# **Site Accessibility Evaluation**

## **Title 24 And Part 2 - California Building Code**

**Central Library**  
**40 E Anapamu St**  
**Santa Barbara Downtown, CA 93101**  
**Accessibility Evaluation**  
**Inspection Date: 08/16/2023**  
**Inspectors: Scott Saddlemire**

**Report Date: 11/03/2023**

### Finding: 3

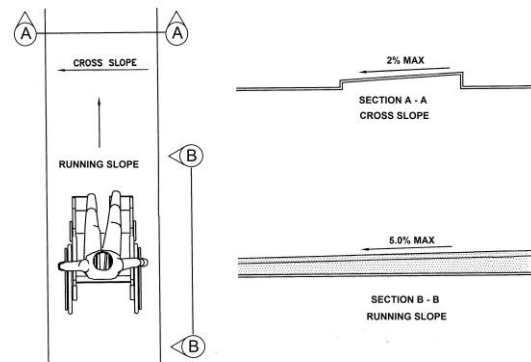
The accessible path of travel between the building entrance and the accessible parking has cross slopes greater than 2%.

Surface cross slopes shall not exceed 1 unit vertical in 48 units horizontal (2-percent slope).

Citation:	As Built:	Budgeting Range:
2010 ADAS Section: 403.3	N/A	\$2,500 - \$9,500.00
2022 CBC 11B Section: 11B-403.3

### Finding: 4

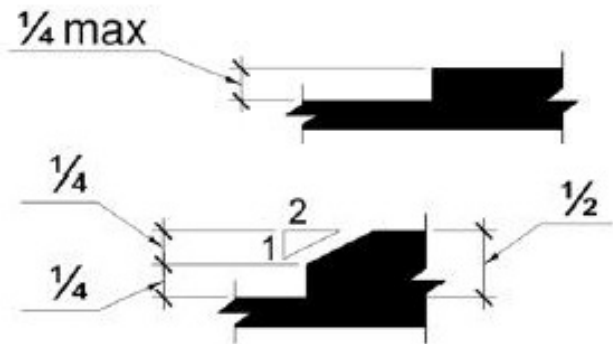
The walkway contains abrupt vertical edges and/or variations over 1/4 inch.

1/4 inch is the maximum vertical rise. Changes in level between 1/4 inch and 1/2 inch must be beveled at 1:2 or less.

Changes in level greater than 1/2 inch must be by way of a ramp.

Walkway (accessible route) from  
parking to entrance

### Finding: 5

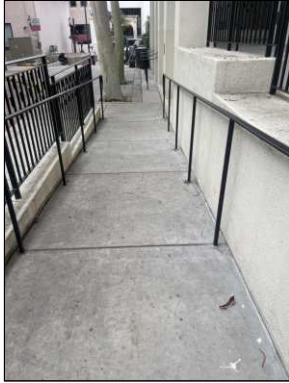
The ramp run and landing do not have compliant/required edge protection.

A curb, or barrier shall be provided that prevents the passage of a 4 inch diameter sphere, where any portion of the sphere is within 4 inches of the finish floor or ground surface. To prevent wheel entrapment, the curb or barrier shall provide a continuous and uninterrupted barrier along the length of the ramp.

chair wheel guade rail

To prevent wheel entrapment, the curb or barrier shall provide a continuous and uninterrupted barrier along the length of the ramp.

Install wheel guide at the bottom of the vertical supports

### Finding: 8

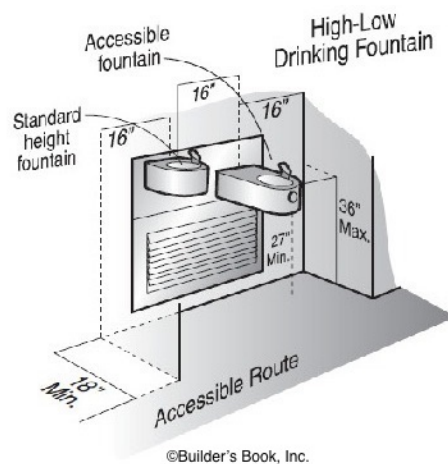
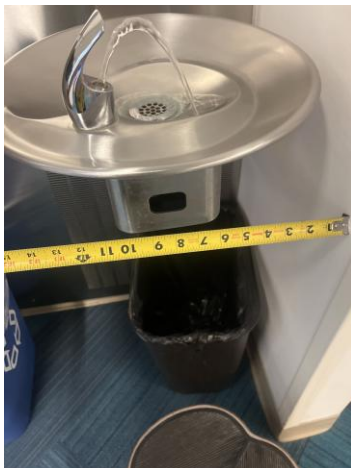
The drinking fountain is noncompliant.

The water flow shall be activated by a manually operated system that is front mounted or side mounted and located within 6 inches of the front edge of the fountain or an electronically controlled device.

Spout outlets on wheelchair accessible fountains shall be 36 inches maximum above the finish floor or ground and be located 15 inches minimum from the vertical support and 5 inches maximum from the front edge of the unit, including bumpers.

The spout shall provide a flow of water at least 4 inches high minimum and shall be located 5 inches maximum from the front of the unit. The angle of the water stream shall be measured horizontally relative to the front face of the unit.

Where spouts are located less than 3 inches of the front of the unit, the angle of the water stream shall be 30 degrees maximum. Where spouts are located between 3 inches and 5 inches maximum from the front of the unit, the angle of the water stream shall be 15 degrees maximum. On an accessible drinking fountain with a round or oval bowl, the spout must be positioned so the flow of water is within 3 inches of the front edge of the fountain.

See figure for requirements to the side of the alcove

### Finding: 9

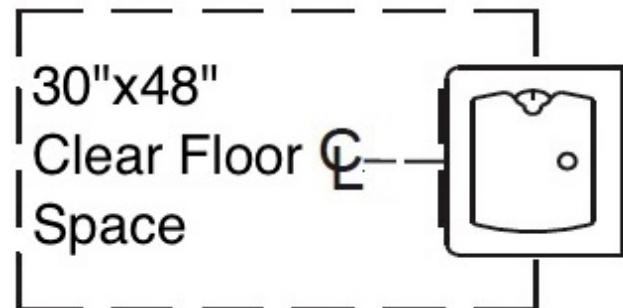
The clear floor space required at accessible drinking fountains is not positioned for a forward approach.

Units shall have a clear floor or ground space positioned for a forward approach and centered on the unit.

Obstructed

### Finding: 10

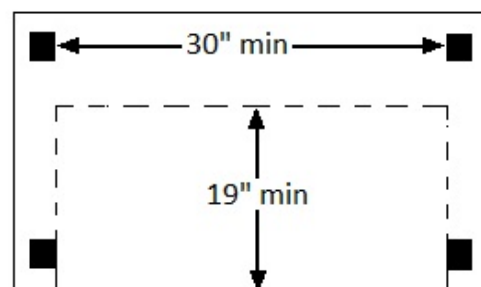
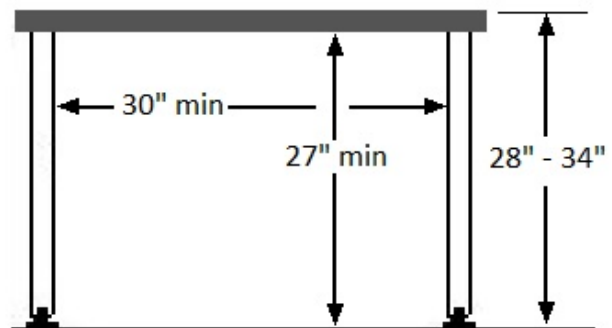
Compliant knee and toe clearance is not provided at the table.

When seating for persons in wheelchairs is provided at fixed tables or counters, knee spaces at least 27 inches high, 30 inches wide and 19 inches deep shall be provided.

long coloring table is compliant,  
individual tables are not

### Finding: 12

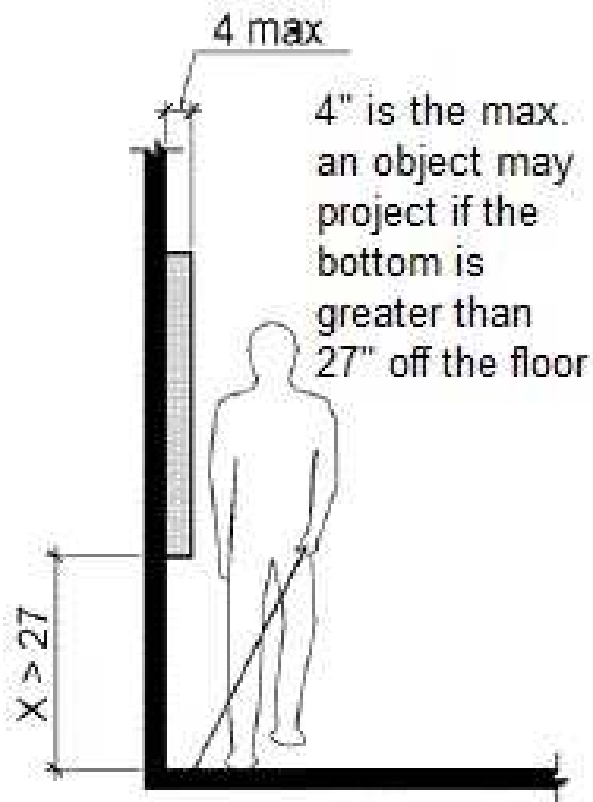
The element projects more than 4 inches into the circulation path.

Wall-mounted objects that have leading edges between 27 inches and 80 inches from the floor must not project more than 4 inches into the circulation path. Protruding objects that extend to the floor or within 27 inches of the floor are cane detectable and are therefore not hazardous. Where it is necessary or desirable to have objects protrude from the wall, a manner of cane detection must be provided.

Typical throughout

### Finding: 13

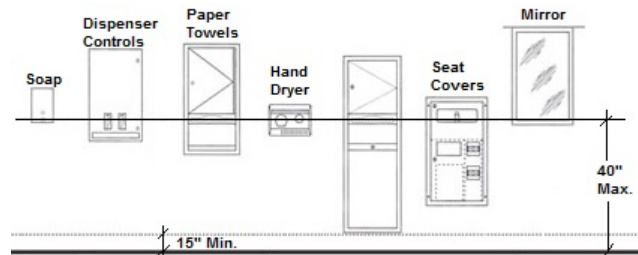
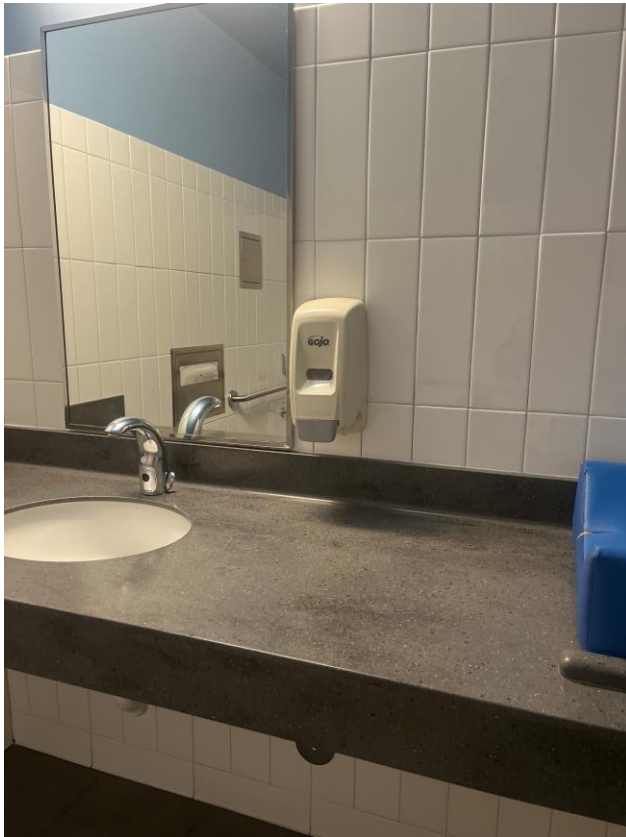
The soap dispenser is mounted too high.

Dispensers must have all operable parts a maximum of 40 inches above the floor.

Citation:	As Built:	Budgeting Range:
2022 CBC 11B Section: 11B-603.5	1/2" too high	\$150 - \$1,500.00

**Recommendation:**  
see figure

### Finding: 15

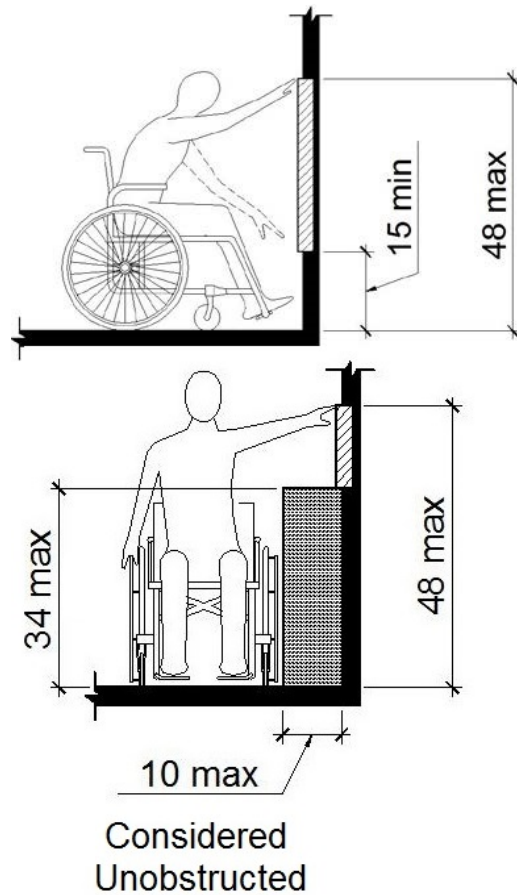
The coat hook is installed greater than 48 inches above the finished floor.

Where a forward reach is unobstructed, the high forward reach shall be 48 inches maximum above the finished floor.

**Basement Floor: Unisex Restrooms in Child Area****Finding: 17**

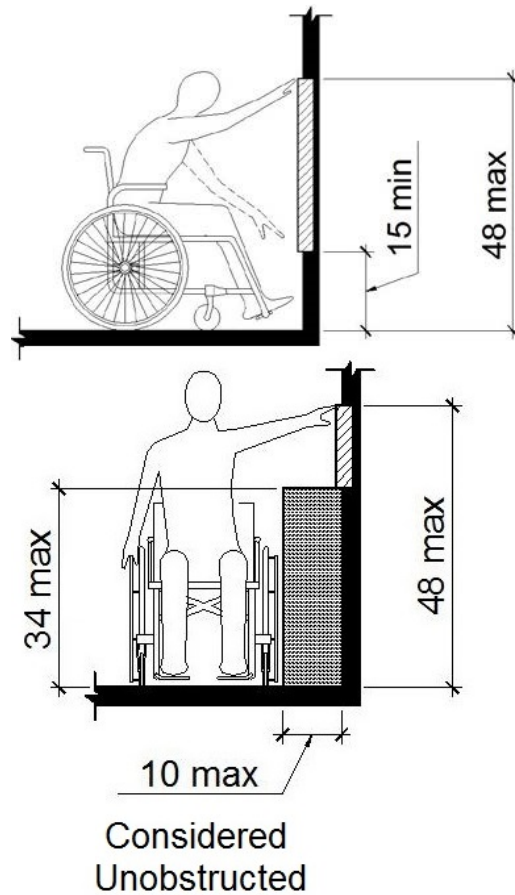
The coat hook is installed greater than 48 inches above the finished floor.

Where a forward reach is unobstructed, the high forward reach shall be 48 inches maximum above the finished floor.

### Finding: 20

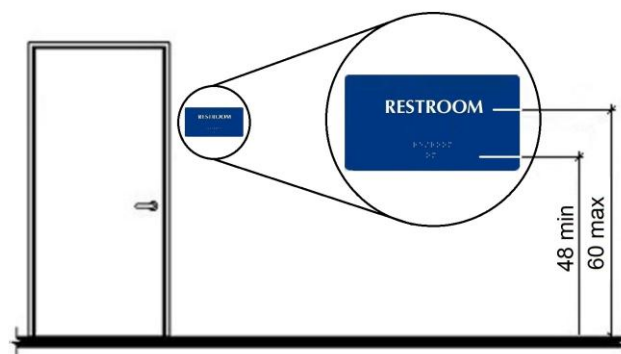
A compliant room identification sign is missing on the strike side of the door.

Wall signs identifying permanent rooms and spaces of a building shall have be horizontal format and the characters raised 1/32 inch minimum and shall be sans serif uppercase characters a minimum of 5/8 inch and a maximum of 2 inches high. Contracted Grade 2 Braille shall be in a horizontal format and shall be placed a minimum of 3/8 inch and a maximum of 1/2 inch directly below the tactile characters; flush left or centered. Signs with raised characters or Braille shall be located a minimum of 48 inches above the finish floor or ground surface, measured from the baseline of the lowest line of Braille and 60 inches maximum above the finish floor or ground surface, measured from the baseline of the highest line of raised characters.

### Finding: 21

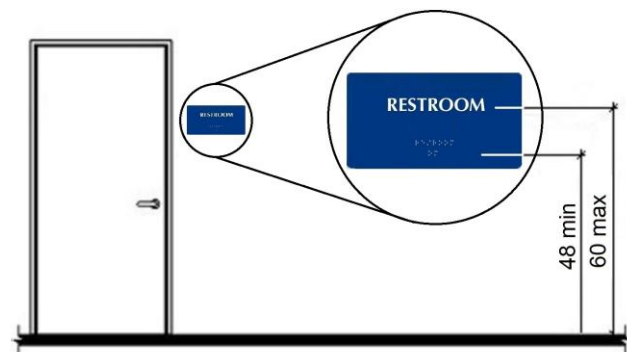
A compliant room identification sign is missing on the strike side of the door.

Wall signs identifying permanent rooms and spaces of a building shall have be horizontal format and the characters raised 1/32 inch minimum and shall be sans serif uppercase characters a minimum of 5/8 inch and a maximum of 2 inches high. Contracted Grade 2 Braille shall be in a horizontal format and shall be placed a minimum of 3/8 inch and a maximum of 1/2 inch directly below the tactile characters; flush left or centered. Signs with raised characters or Braille shall be located a minimum of 48 inches above the finish floor or ground surface, measured from the baseline of the lowest line of Braille and 60 inches maximum above the finish floor or ground surface, measured from the baseline of the highest line of raised characters.

### Finding: 22

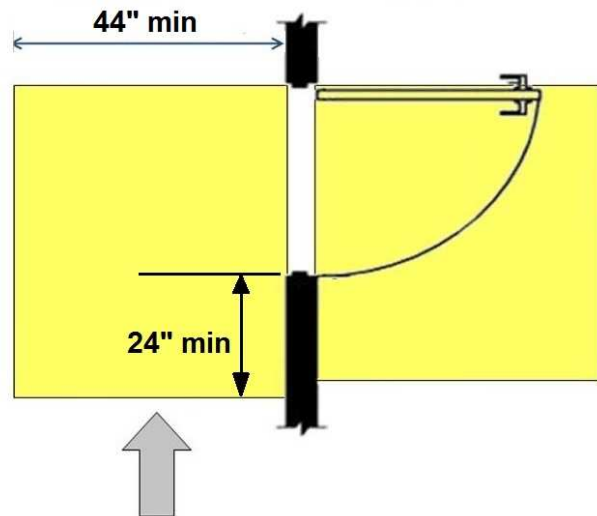
The maneuvering clearance perpendicular to the door on the push side does not meet the minimum required dimension.

Maneuvering clearance at doors on the push side that are approached from the latch side must be 44 inches perpendicular to the door and the area adjacent to the latch side and in the same plane as the door must be unobstructed for a distance of 24 inches.

### Finding: 23

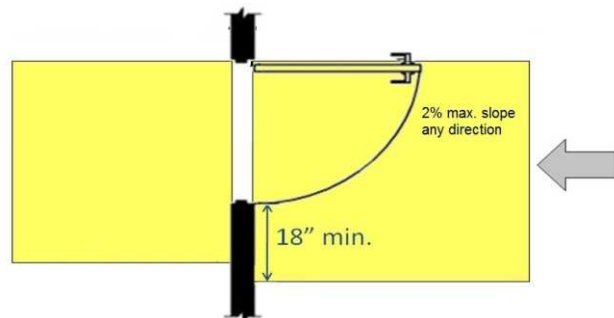
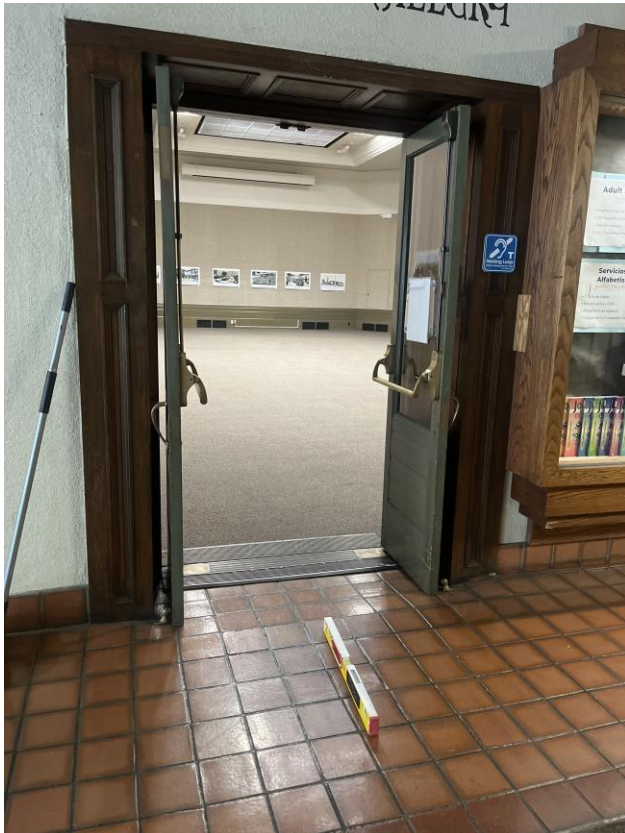
The maneuvering clearance at the door exceeds 2% slope.

Maneuvering clearance for interior doors on the pull side with a front approach must be flat (2% max. slope in any direction) for a minimum distance of 60 inches in the direction of travel. The width of the maneuvering clearance must be as wide as the door plus an additional 18 inches on the latch side. This latch side clearance must also be flat (2% max. slope in any direction) and clear of obstructions.

South set of doors

### Finding: 24

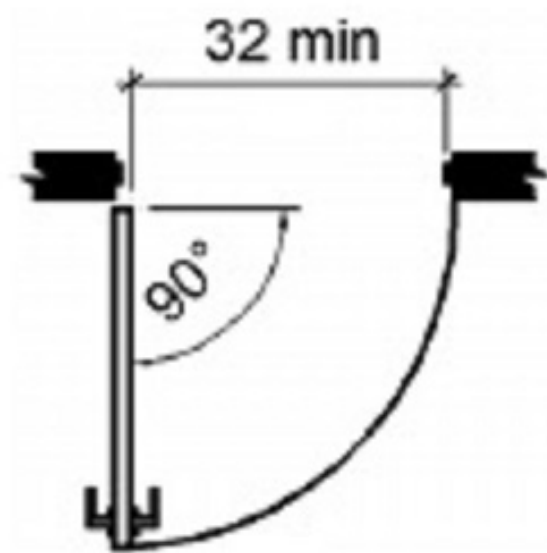
Neither leaf of the doorway provides at least 32 inches between the face of the door and the opposite stop.

At least one of the active leaves of doorways with two leaves shall comply with clear width and maneuvering clearance.

Door openings shall provide a clear width of 32 inches minimum. Clear openings of doorways with swinging doors shall be measured between the face of the door and the stop, with the door open 90 degrees.

south set of doors

### Finding: 25

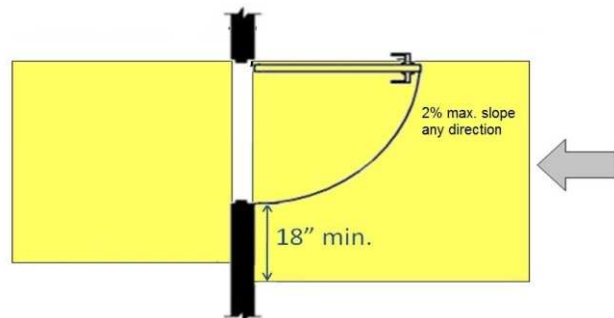
The maneuvering clearance at the door exceeds 2% slope.

Maneuvering clearance for interior doors on the pull side with a front approach must be flat (2% max. slope in any direction) for a minimum distance of 60 inches in the direction of travel. The width of the maneuvering clearance must be as wide as the door plus an additional 18 inches on the latch side. This latch side clearance must also be flat (2% max. slope in any direction) and clear of obstructions.

north set of doors

### Finding: 26

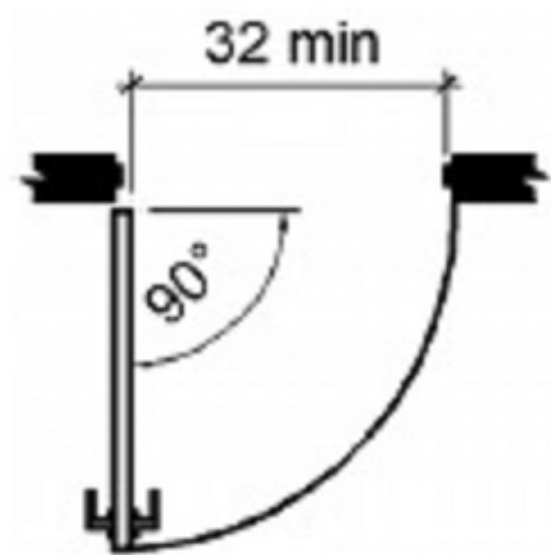
Neither leaf of the doorway provides at least 32 inches between the face of the door and the opposite stop.

At least one of the active leaves of doorways with two leaves shall comply with clear width and maneuvering clearance.

Door openings shall provide a clear width of 32 inches minimum. Clear openings of doorways with swinging doors shall be measured between the face of the door and the stop, with the door open 90 degrees.

north set of doors

### Finding: 27

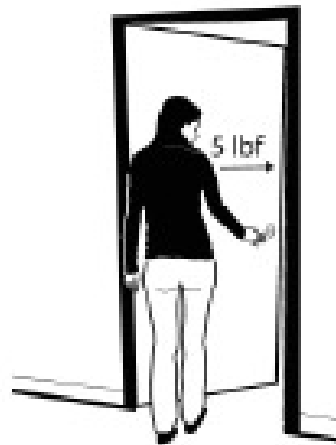
The door exceeds the maximum allowable opening force.

Doors shall have a maximum opening force of 5 pounds.

hits the ground

### Finding: 29

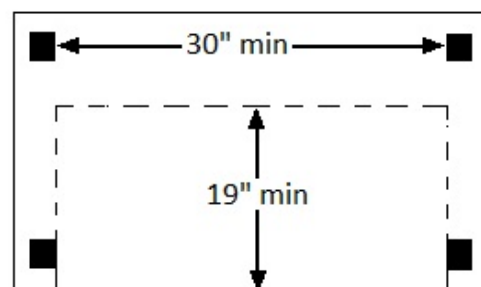
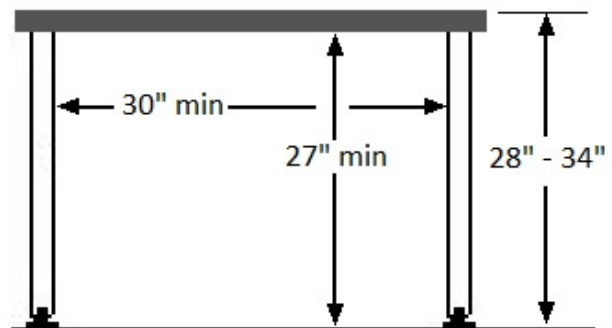
Compliant knee and toe clearance is not provided at the table.

When seating for persons in wheelchairs is provided at fixed tables or counters, knee spaces at least 27 inches high, 30 inches wide and 19 inches deep shall be provided.

### Finding: 30

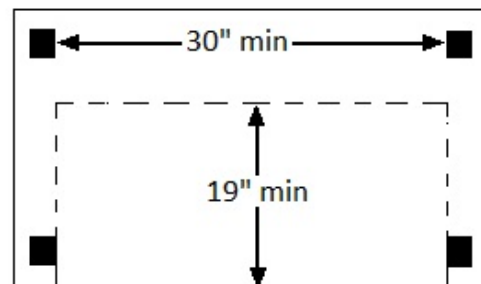
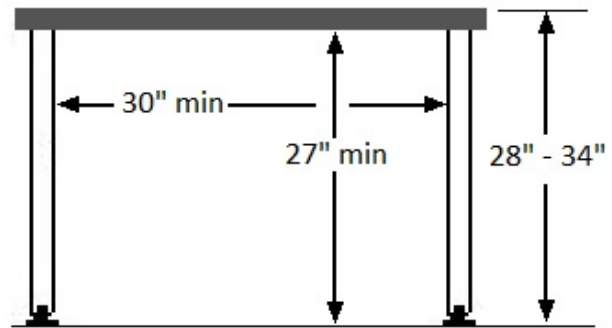
Compliant knee and toe clearance is not provided at the table.

When seating for persons in wheelchairs is provided at fixed tables or counters, knee spaces at least 27 inches high, 30 inches wide and 19 inches deep shall be provided.

### Finding: 31

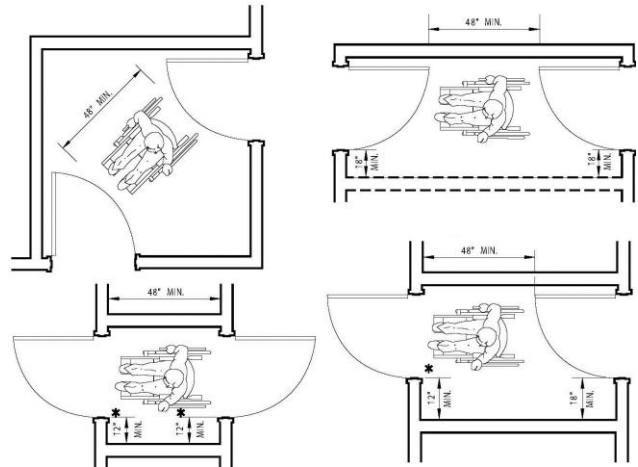
The maneuvering space between the two doors in the vestibule is noncompliant.

The distance between two hinged or pivoted doors in series shall be 48 inches minimum plus the width of doors or gates swinging into the space.

### Finding: 32

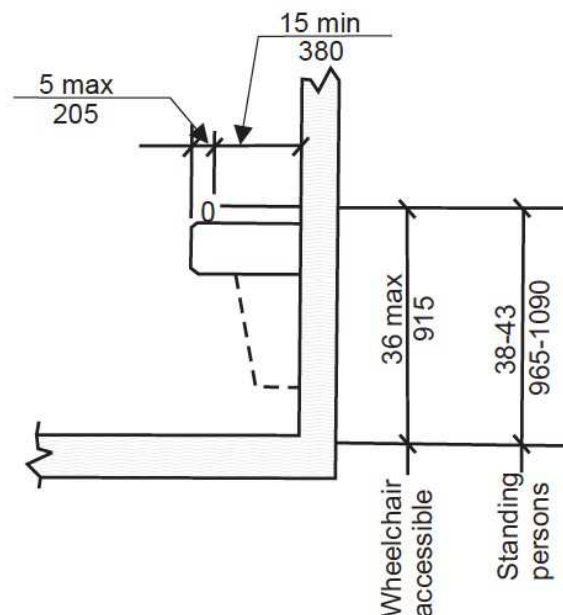
There is no drinking fountain for standing persons.

No fewer than two drinking fountains shall be provided. One drinking fountain shall meet requirements for wheelchair accessibility and one drinking fountain shall meet requirements for standing persons.

Spout outlets of drinking fountains for standing persons shall be 38 inches minimum and 43 inches maximum above the finish floor or ground.

no standing fountain

### Finding: 33

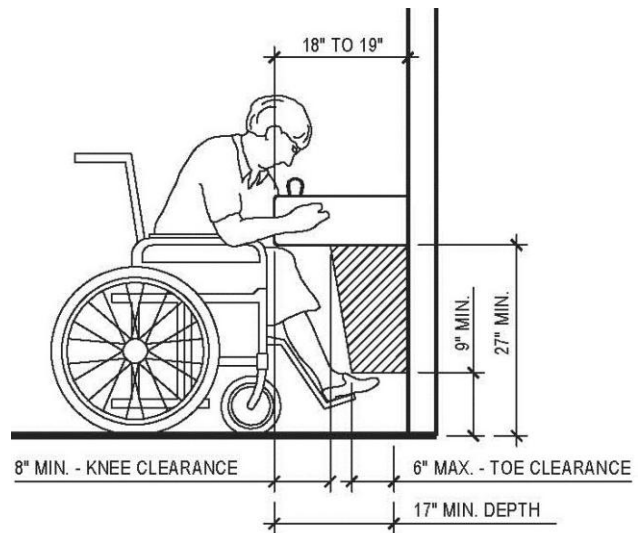
There is not enough knee clearance under the drinking fountain.

The drinking fountain must have a clear knee space between the bottom of the drinking fountain and the floor not less than 27 inches in height, 30 inches in width, and 8 inches in depth.

too low

see figure

### Finding: 34

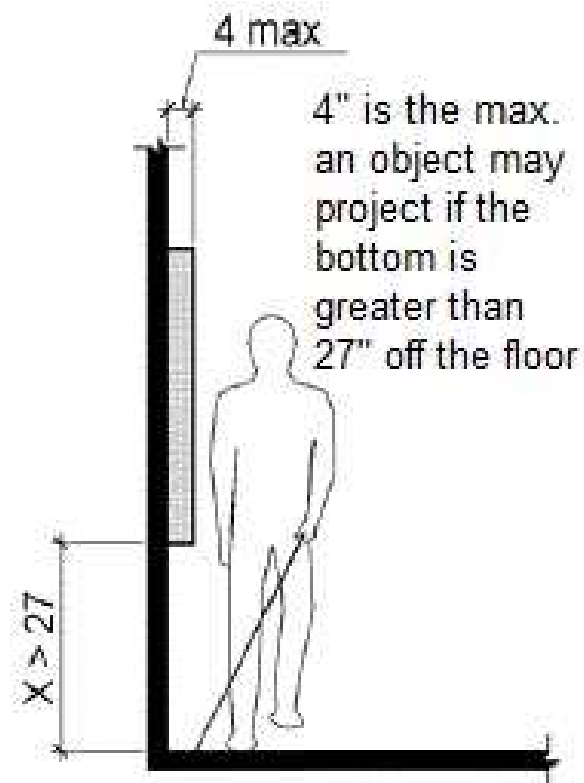
The element projects more than 4 inches into the circulation path.

Wall-mounted objects that have leading edges between 27 inches and 80 inches from the floor must not project more than 4 inches into the circulation path. Protruding objects that extend to the floor or within 27 inches of the floor are cane detectable and are therefore not hazardous. Where it is necessary or desirable to have objects protrude from the wall, a manner of cane detection must be provided.

no high fountain

Once a complaint Hi/low drinking fountain is installed, ensure that the protruding drinking fountain is cane detectable
